CITY of NOVI CITY COUNCIL

Agenda Item 3
July 23, 2018

SUBJECT: Consideration of the request of DTN Management/Tricap Holdings for approval of the Preliminary Site Plan, Phasing Plan, Woodlands Permit, and Storm Water Management Plan, JSP 18-10, and the request to rename Flint Street to Bond Street. The property is zoned TC-1 (Town Center One) and is approximately 7.74 acres. It is located on the southwest side of Flint Street south of Grand River Avenue and west of Novi Road. The applicant is proposing a mixed-use development called The Bond, with two four-story multi-family residential buildings with a total of 253 apartments and a 5,578 square foot single-story commercial building.

R.O.W. TAKING PLAN AND OPEN SPACE PLAN

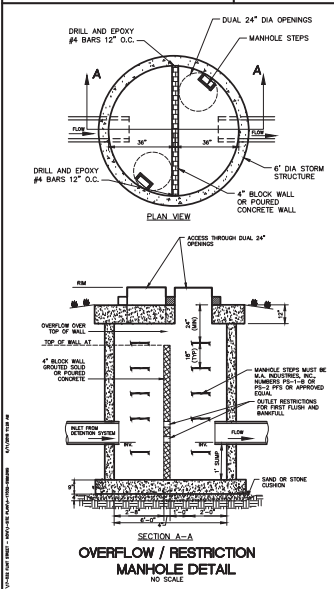
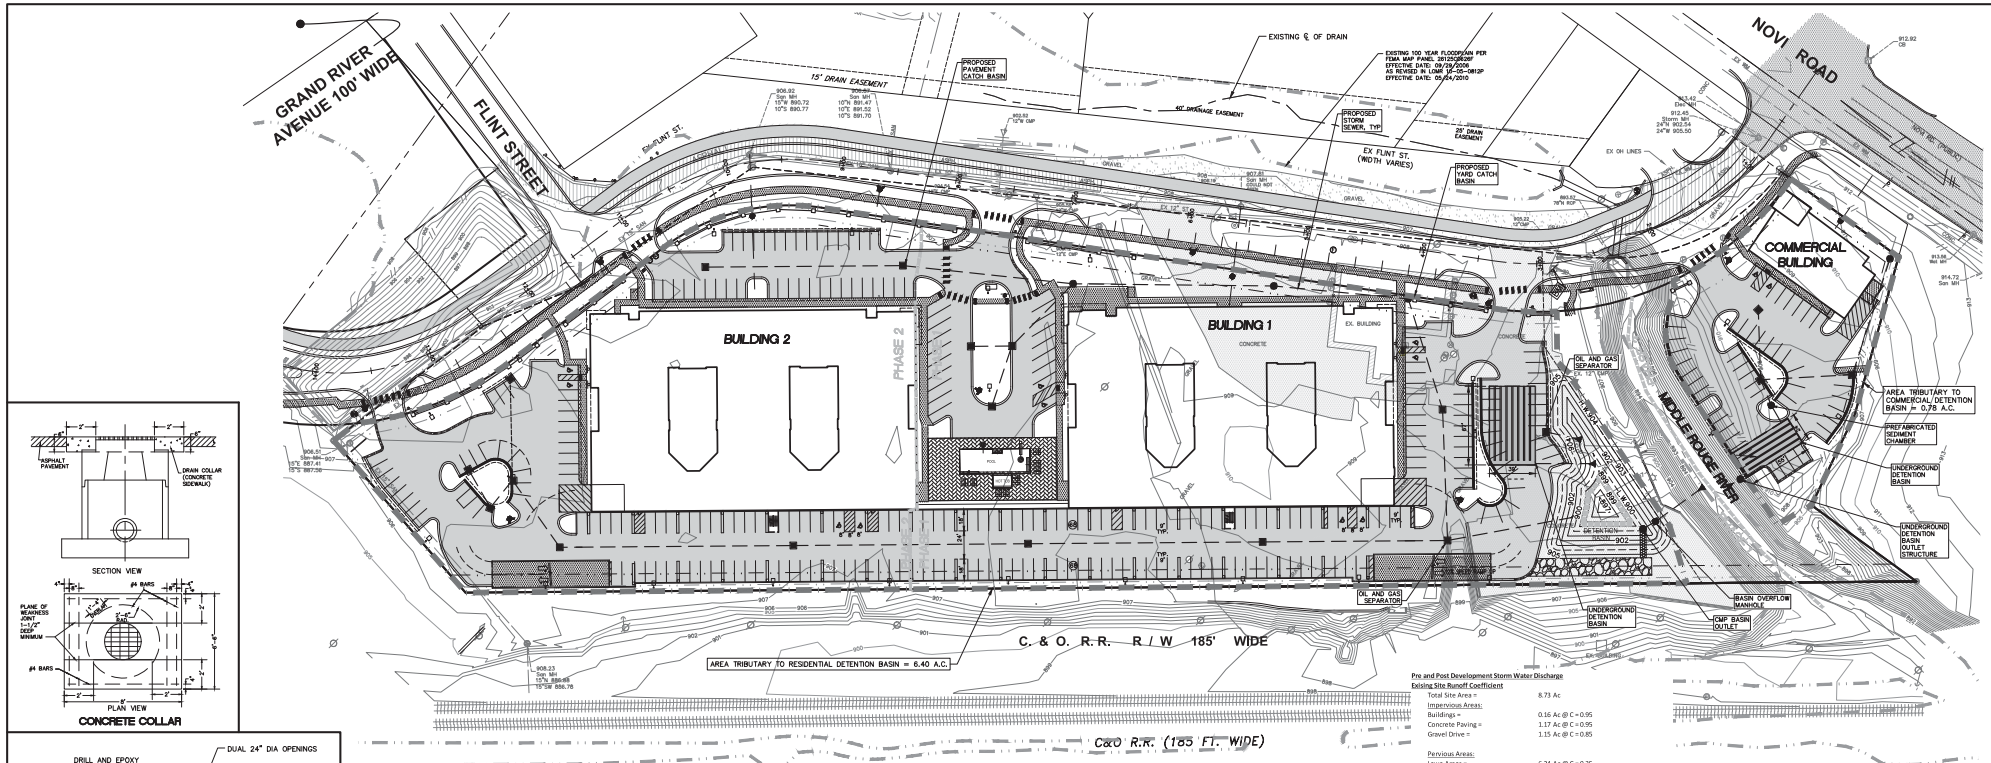
6. Sheet Title: **Sheet No.3 is referred to as 'Right-of-way Taking Plan.'** The City is not "taking" the area indicated; rather, the applicant is offering the land voluntarily to accommodate Flint/Bond street realignment. **Please rename the sheet accordingly.**

PHASING PLAN

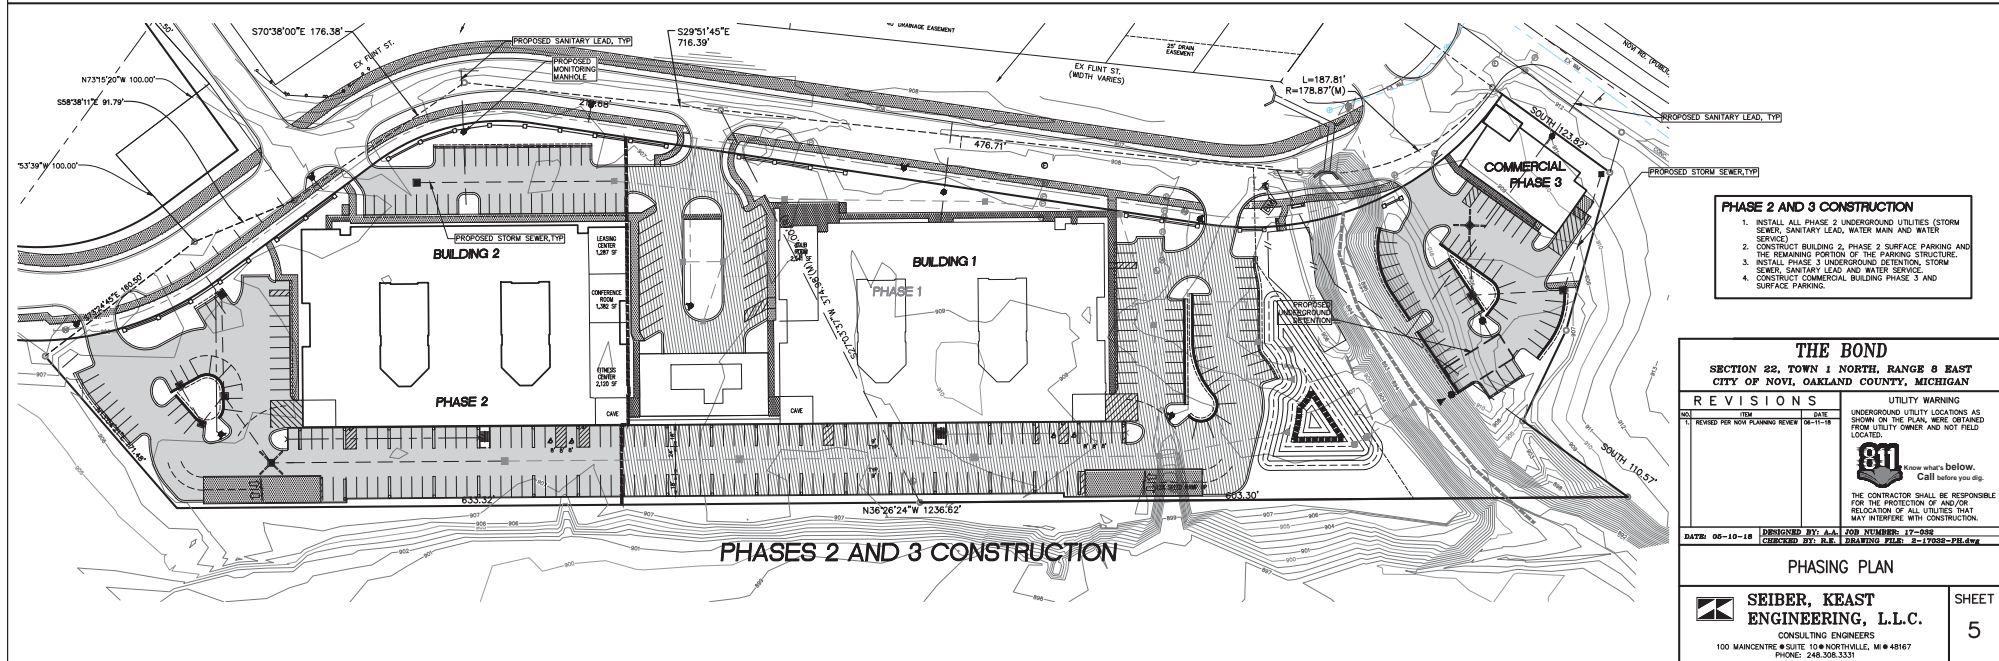
8. Phasing: The applicant is proposing to phase the construction in three phases. Per sheet 5, the phases are listed as follows:

- a. Phasing (Pg 2 of 19) – Building and parking counts will be added to the Phasing Plan
 - b. Building Height (Pg 3 of 19) – Maximum building height will be added to the Site Plan Data on sheet 2 of the Site Plan

Figure 1. City of Novi Regulated Wetland & Woodland Map (approximate property boundary shown in red). Regulated Woodland areas are shown in green and regulated Wetland areas are shown in blue.

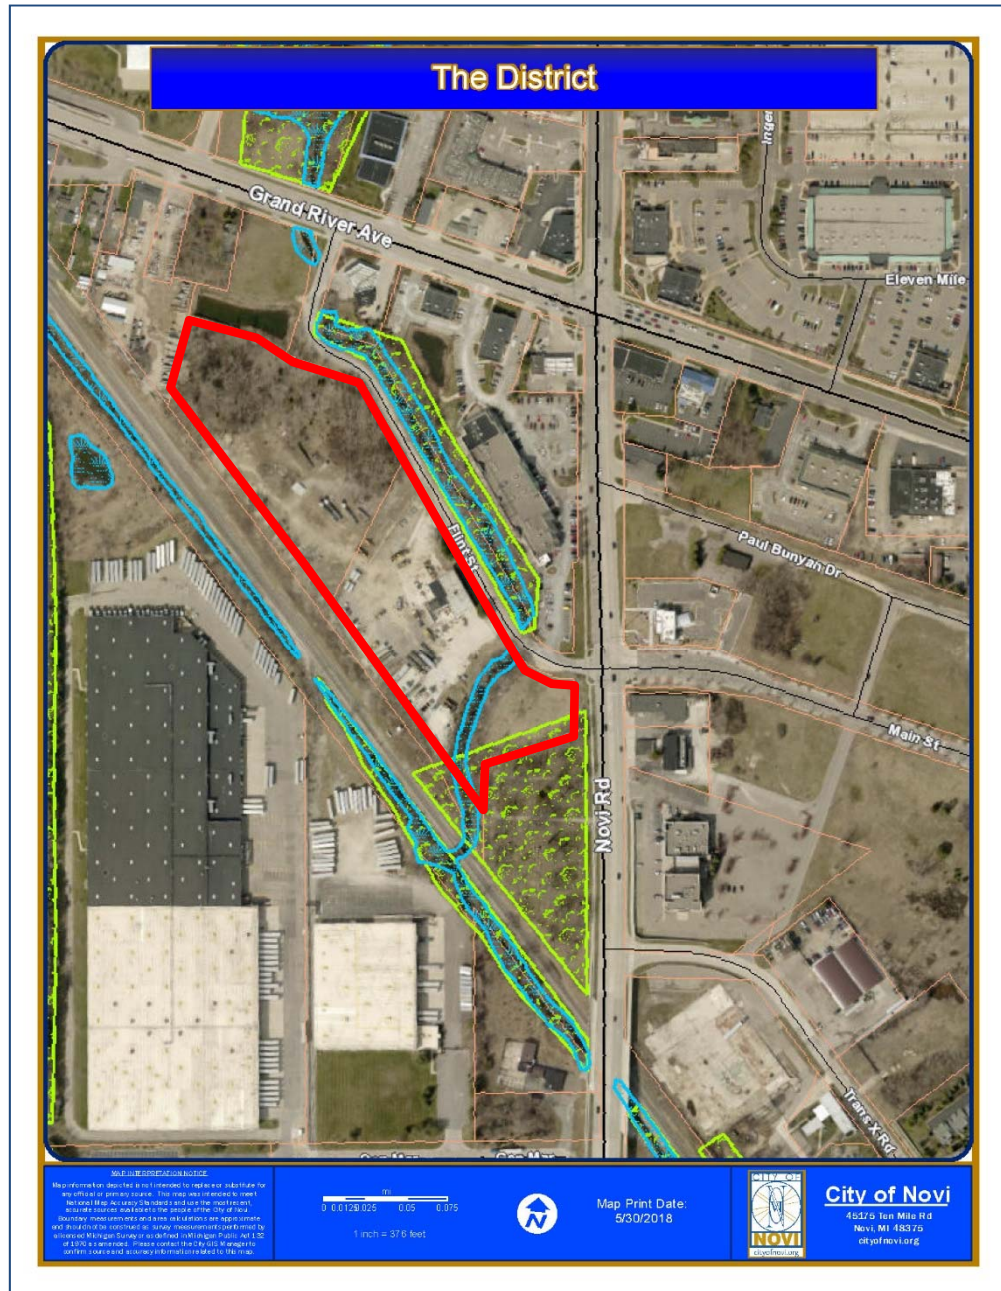
ECT completed an on-site woodland evaluation on November 7, 2017. The site appears to contain an area indicated as City of Novi Regulated Woodlands (see Figure 1). This area is located in the southeast section of the site, along the Walled Lake Branch of the Middle Rouge River. Areas mapped as Regulated Woodlands are also located adjacent to the site, across Flint Street.
